- Request - Major Site Plan Review for a New Parking Lot
- Location - 600 Matzinger Road
- Applicant / Owner - Perstorp Polyols Toledo
600 Matzinger Road
Toledo, OH 43612
- Civil Engineer - Wade Trim Associates, Inc.
2851 Charlevoix Drive SE, Suite 108
Grand Rapids, MI 49546

The staff recommends that the Toledo City Plan Commission approve SPR26-0006, a Major Site Plan Review for a New Parking Lot at 600 Matzinger Road, for the following two (2) reasons:

MAJOR SITE PLAN REVIEW
TOLEDO CITY PLAN COMMISSION
REF: SPR26-0006
DATE: March 12, 2026
TIME: 2:00 P.M.

SITE PLAN

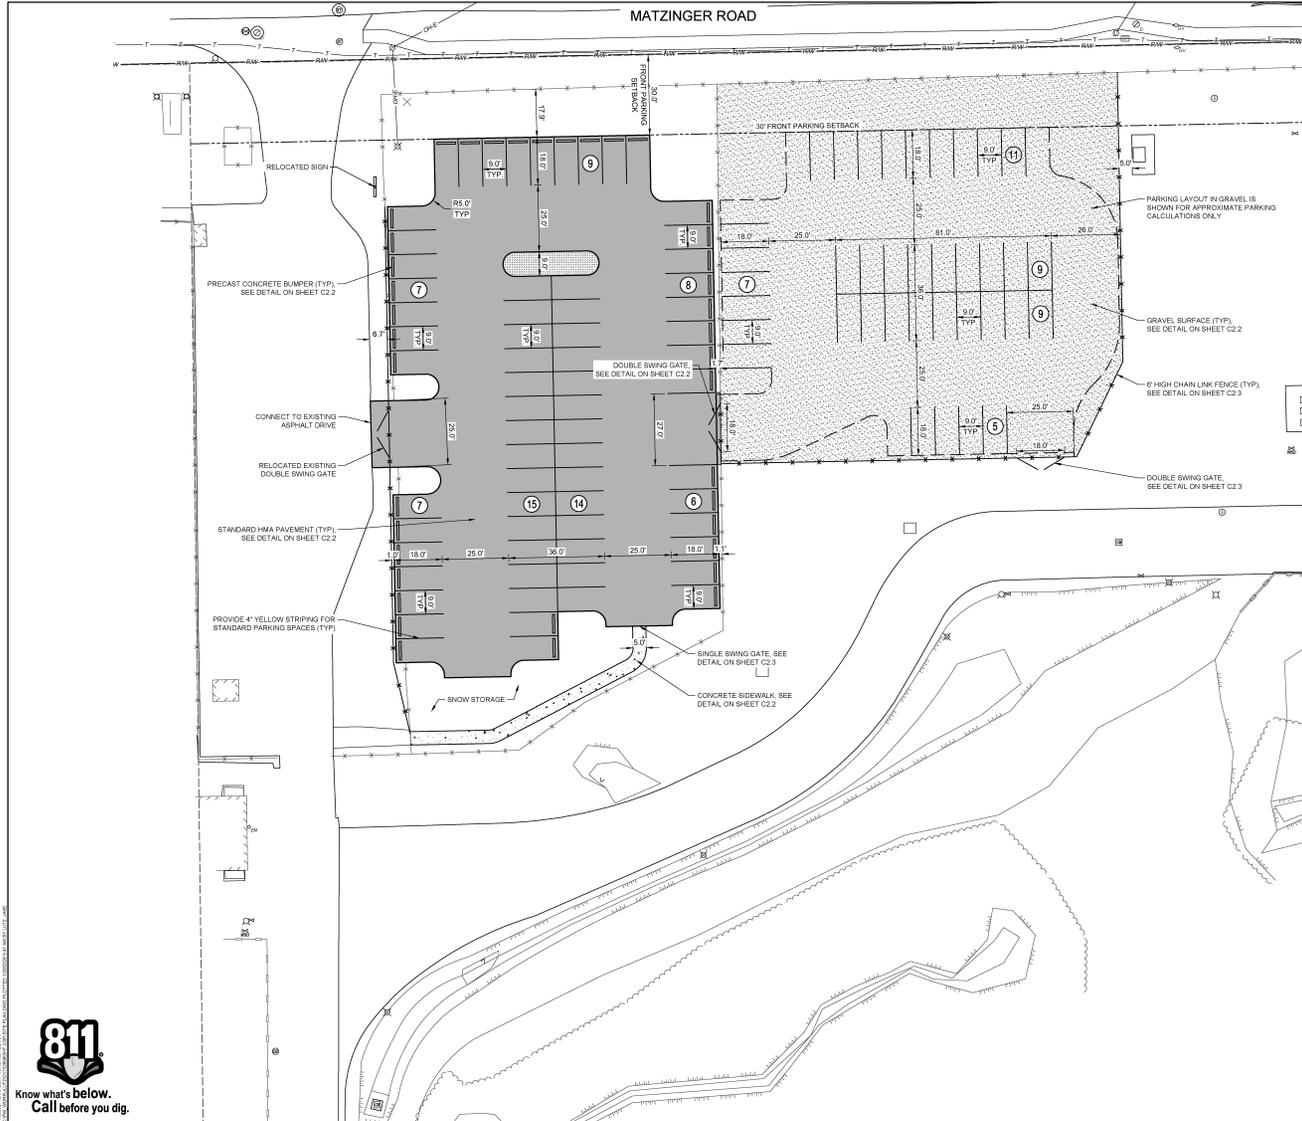
TMC§1107.1906 *Surfacing and Drainage* requires all off-street parking and loading areas, parking lots, maneuvering areas, aisles, and driveways to be surfaced with concrete, bituminous asphalt, or other dust-free material other than gravel or loose fill. The eastern portion of the proposed parking lot would be made of gravel. The applicant is requesting a variance from this requirement for this portion of the parking lot because it would be used only twice a year during shutdown periods – occurring in the fall and spring. The applicant will need to obtain a variance from the Board of Zoning Appeals (BZA). Staff is not supportive of this variance. If the Board of Zoning Appeals denies this variance the applicant will be required to submit a revised site plan depicting all parking lots surfaced with concrete, bituminous asphalt, or other dust-free material. This has been added as a condition of approval.

With 173 parking spaces proposed, TMC§1107.1700 *Accessible Parking for Physically Disabled Persons* requires a minimum of one (1) van- and five (5) auto-accessible parking spaces on this site. There are currently two (2) van-accessible and three (3) auto-accessible spaces on site; however, none are depicted. The applicant shall submit a revised site plan depicting a number of accessible parking spaces on site in compliance with TMC§1107.1700 and the Americans with Disabilities Act.

TMC§1107.0900 *Bicycle Parking* requires a minimum of one (1) bicycle parking space for every ten (10) vehicle parking spaces. None are currently depicted. The applicant shall submit a revised site plan depicting a minimum of one (1) bicycle parking space for every ten (10) vehicle parking spaces on this site. This has been added as a condition of approval.

4. The stormwater proposal is acceptable for site planning, but the size of the underground detention basin will need confirmed during engineering plan review and possibly enlarged to provide for the required water quality volume, flood control, and restricted discharge rate. Pretreatment shall be sized according to Ohio requirements.

15. Bicycle parking is required per TMC§1107.0900. **Not acceptable as depicted. Applicant shall submit a revised site plan depicting one (1) bicycle parking space for every ten (10) vehicle parking spaces. Bicycle parking spaces shall meet the standards of TMC§1107.0900.**
16. Five (5) auto and one (1) van accessible parking with 5' loading aisle for auto and 8' loading aisle for van is required per TMC§1107.1701 & 1107.1702. **Not acceptable as depicted. The applicant shall submit a revised site plan depicting all accessible parking spaces on site and ensuring compliance with TMC§1107.1701 & 1107.1702.**
17. All off-street parking, loading spaces, parking lots, maneuvering areas, drive aisles and driveways must be surfaced with concrete, asphalt or other dust free material other than gravel or loose fill per TMC 1107.1906.

18. Per TMC§1107.1906 *Surfacing and Drainage*, off-street parking and loading spaces, parking lots, maneuvering areas, aisles and driveways must be surfaced with concrete, bituminous asphalt, or other dust-free material other than gravel or loose fill. **Not acceptable as depicted. The applicant shall either obtain a variance from the Board of Zoning Appeals or submit a revised site plan showing compliance with TMC§1107.1906.**

LANDSCAPE PLAN

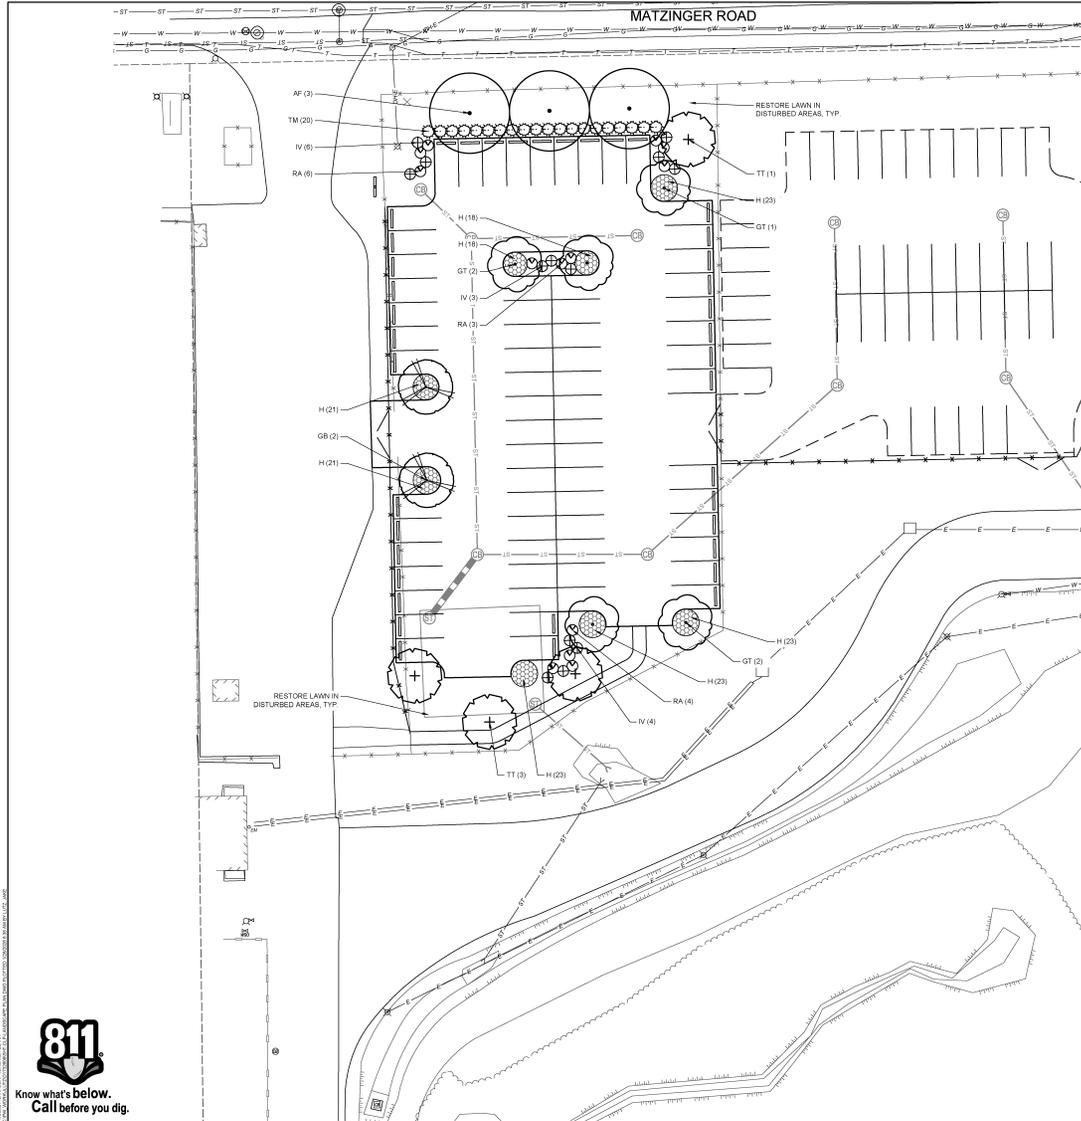
TMC§1108.0202 *Frontage Greenbelt* requires a minimum thirty-foot (30') wide frontage greenbelt along Matzinger Road. This greenbelt must contain at least one (1) tree for every thirty linear feet (30') of frontage and a solid evergreen hedge planting. SPR-47-23, a Minor Site Plan Review for a New Industrial Building and Parking Lot at 632 Matzinger Road, was approved on March 8, 2024 and included a final landscape plan approved on March 14, 2024. This landscape plan depicted trees along the Matzinger Road frontage greenbelt adjacent to this proposed parking lot. A site visit on February 24, 2026 showed that most but not all of these trees were planted. The applicant shall submit a revised landscape plan depicting currently-planted trees and ensuring that a minimum of one (1) tree is planted for every thirty linear feet (30') within the frontage greenbelt adjacent to the proposed parking lot. This has been added as a condition of approval.

19. Per TMC§1108.0202 *Frontage Greenbelt*, a minimum of one (1) tree is required within the frontage greenbelt along Matzinger Road for every thirty feet (30') of lot frontage. **Not acceptable as depicted. The applicant shall submit a revised landscape plan depicting all existing trees within the Matzinger Road frontage greenbelt and ensuring a minimum of one (1) tree for every thirty feet (30') of lot frontage adjacent to the proposed site improvements.**

23. The location, number, height, diameter and species of any materials to be planted and maintained shall be depicted on a detailed 'final' landscape plan, as well as the location and number of any existing trees to be retained. Trees, shrubs, and landscape materials shall meet the standards included in TMC§ 1108.0400 *Landscape Materials Standards*.
